REQUEST FOR INTER PARTES REEXAMINATION TRANSMITTAL FORM

1. This is a request for *inter partes* reexamination pursuant to 37 CFR 1.913 of patent number 6,366,130 issued April 2, 2002. The request is made by a third party requester, identified herein below.

Response to Non-Final Office Action and Amendment

Response to PO's Remarks and 3PR's Comments

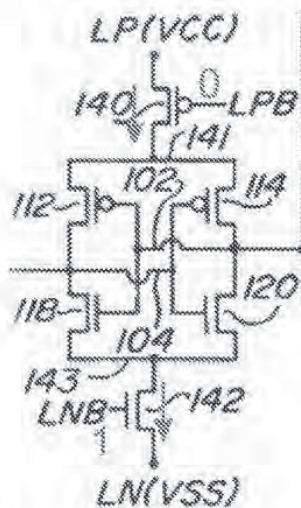
39. On page 21 of the Reexamination Request, it is alleged that "a latching sense amplifier coupled to the differential bus" is satisfied by the Latch & Sense Amp show in the preceding figure. However, during the write cycle Hardee does not teach this circuit operating as a latching sense amp.

41. While operation of the sense amp is described for reads, Hardee does not specify the values of LPB and LNB during a write operation. Thus, a practitioner of ordinary skill in the art would be forced to speculate as to how the latch operates during a write. It is clear that these signals are manipulated during reads (Hardee 13:24-35) and are not statically set values. But there is no mention as to their values during writes. I shall speculate as to an illustrative possibility, but it is impossible to know with certainty what Hardee had in mind for this operation.

42. In my opinion the most likely speculative possibility is that LPB is low and LNB is high during the entire write operation. This connects node 141 to power and node 143 to ground, forming a classical bistable latch:

44. Given the strong drive provided by transistors 128, 130, 132 and 134, there is no other mode of operation I can envision that would have the "latching sense amp" operating as an actual sense amp. In my opinion it is acting as a latch in this scenario regardless of whether my conjecture as to operation is correct.

45. Therefore, during a write operation the "sense amp" circuit taught by Hardee is being operated as a latch, not as a "latching sense amp" as required by the Podlesny claims. As a result, it is my opinion that during a write operation there is no latching sense amplifier coupled to the differential bus, but rather the circuit is configured to provide just a latch with no sense amplifier functionality.

FIG. 1.

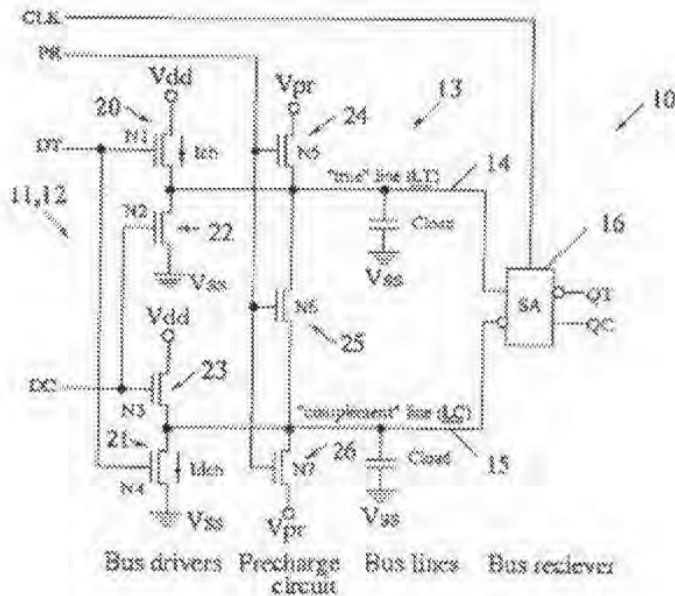
As to **claim 9**, PO states that this claim is described by figures 1-2 and column 2 where in figure 1, the differential bus LT/LC, precharges to the voltage V_{pr} (col.2:19-21) and the differential data bus in figure 2 precharges to V_{dd} (col.2:55-56). (Comments, pg. 4)

First, it is found that figure 1 describes V_{pr} but does not describe 'precharging'. Second, it is found that figure 2 describes V_{dd} but does not describe precharging. Third, it is found that col.2:19-21 discusses precharging V_{pr} but does not describe that the 'differential bus' is precharged to a different voltage than the 'differential data bus' because the value of V_{pr} with respect to the voltage at which the 'differential data bus' is not disclosed. Fourth, it is found that col.2:55-56 discusses precharging V_{dd} but does not describe the 'differential bus' is precharged to a different voltage than the 'differential data bus' because the value of V_{pr} with respect to V_{dd} is not disclosed.

We agree with Requester and the Examiner that the '130 Patent does not provide adequate written description for newly added claim 9. While one of ordinary skill in the art might use the disclosure to figure out a way to precharge the indicated differential data bus to a voltage that is different than the differential bus, a description which renders obvious a claimed invention is not sufficient to satisfy the written description requirement of that invention. *Lockwood v. American Airlines, Inc.*, 107 F.3d 1565, 1572 (1997). Thus, the rejection of claim 9 as lacking written descriptive support in the '130 Patent is affirmed.

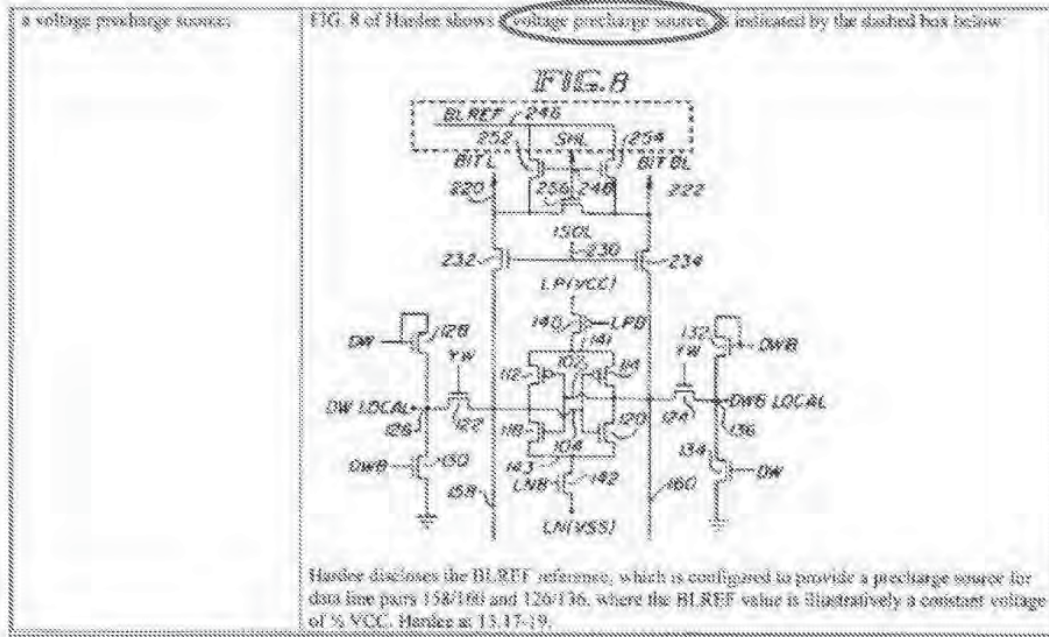
5. PO's remarks, 3PR's comments, the **Taylor Declaration**, and the **Koopman Declaration** have been considered and weighed and 3PR's argument is found not persuasive for the reasons below. As such, the rejection of **claims 1-2 and 5-7** as being anticipated by **Hardee** is withdrawn.

6. **Claims 1-2, 5-7, and 9-12** require, *inter alia*, (1) a voltage precharge source, (2) differential bus, and (3) a differential data bus.

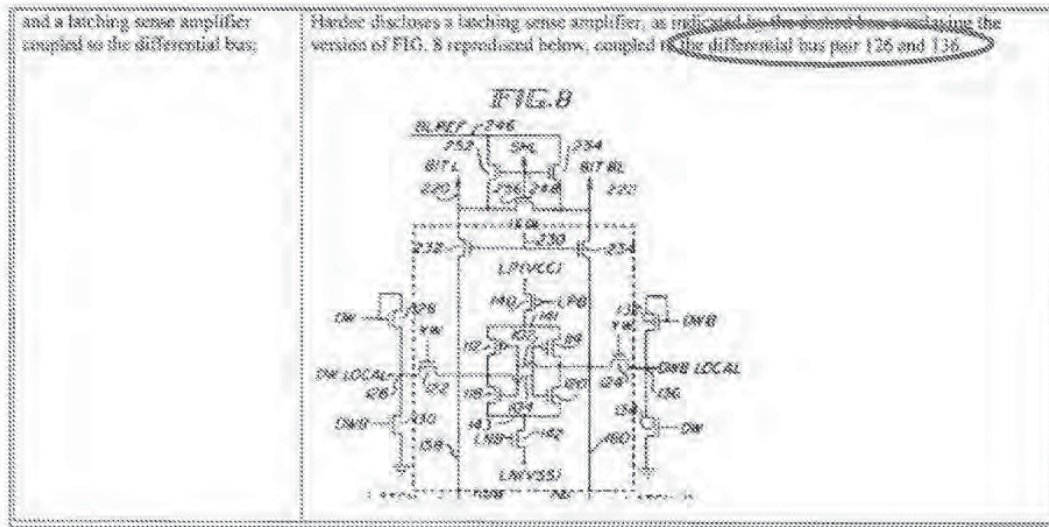
As to the claimed 'voltage precharge source', 3PR argues the BLREF #246 (figure 8) of **Hardee** reads on this limitation. (Request, pg. 20)

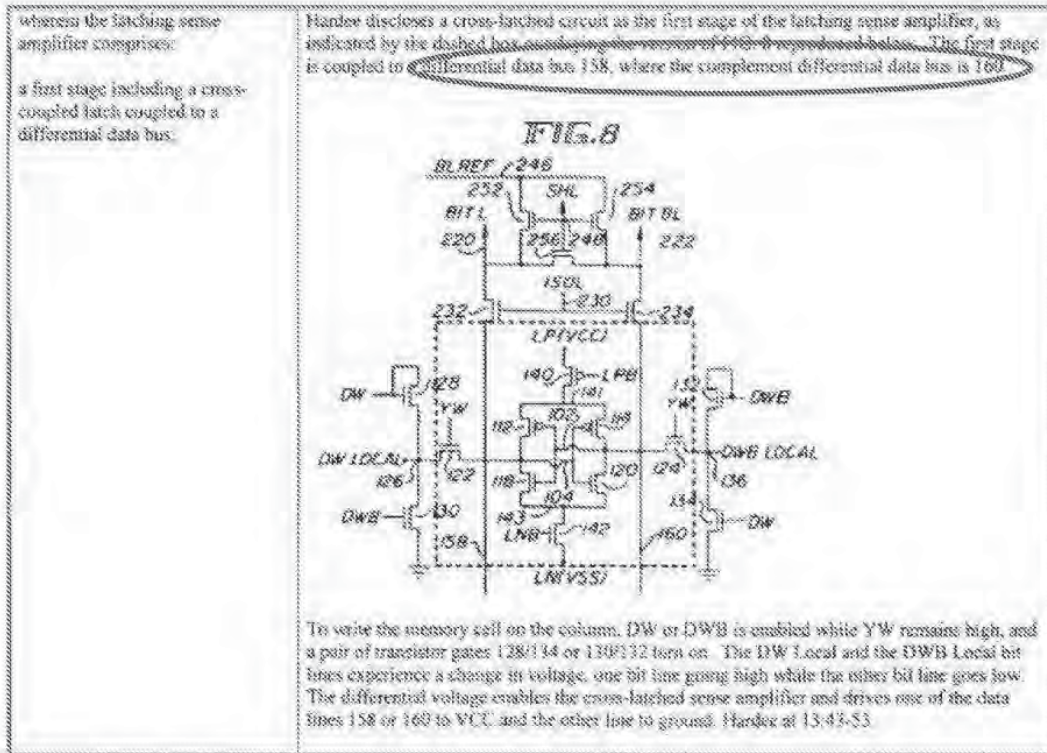
As to the claimed 'differential bus', 3PR argues DW LOCAL #126 or DWB LOCAL #136 of **Hardee** reads on this limitation. (Request, pg. 21)

As to the claimed 'differential data bus', 3PR argues Data Line #158 of **Hardee** reads on this limitation. (Request, pg. 22)

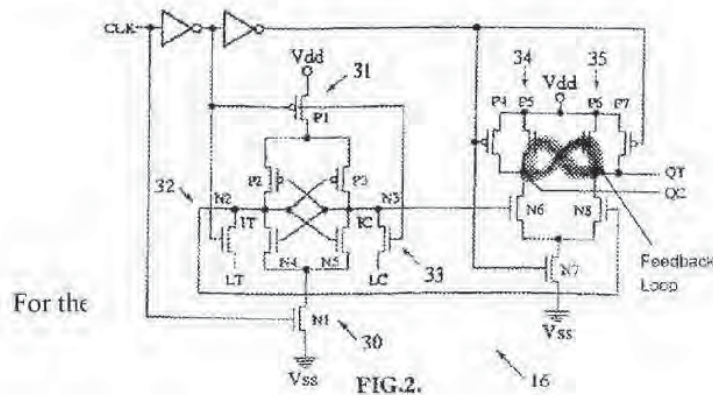
As to **claim 10**, PO states figure 2 clearly shows a cross-coupled output stage. (Comments, pg. 4) Although it is agreed that figure 2 clearly shows a cross-coupled output stage, it is not agreed that figure 2 describes "the output stage includes a cross-coupled feedback", as claimed, because figure 2 does not describe the 'feedback' limitation.

Here the examiner admits that that Figure 2 shows a cross-coupled output stage. The examiner however, states that Figure 2 does not show cross-coupled feedback.

Upon examination of the right-hand part of Figure 2 (the output stage) consisting of transistors P4, P5, P6, P7, N6, N7 and N8, it can be clearly seen that there are two outputs, QT and QC.

Therefore, Figure 2 alone provides sufficient support for the limitation of claim 10 that the output stage includes cross-coupled feedback. This is clearly shown in the figure below as a marked loop.

Requester provides several modes of operation of the circuit in Figure 2 that Requester argues proves the circuit lacks an output stage feedback loop. 3PR Resp. Br. 5-8. However, we do not find this evidence to be persuasive that a cross-coupled feedback loop does not exist, especially in light of the fact that Requester does not argue that Patent Owner's definition of cross-coupled feedback is in error or that the circuit is not set up in a cross-coupled feedback loop configuration. Additionally, we disagree with the Examiner that "feedback" is not described by the Figure. While Patent Owner's Specification might not make mention of the term, we agree with Patent Owner that one of ordinary skill in the art would know what a feedback circuit looks like and that one is disclosed by Figure 2. As such, we cannot sustain the Examiner's rejection of claim 10.
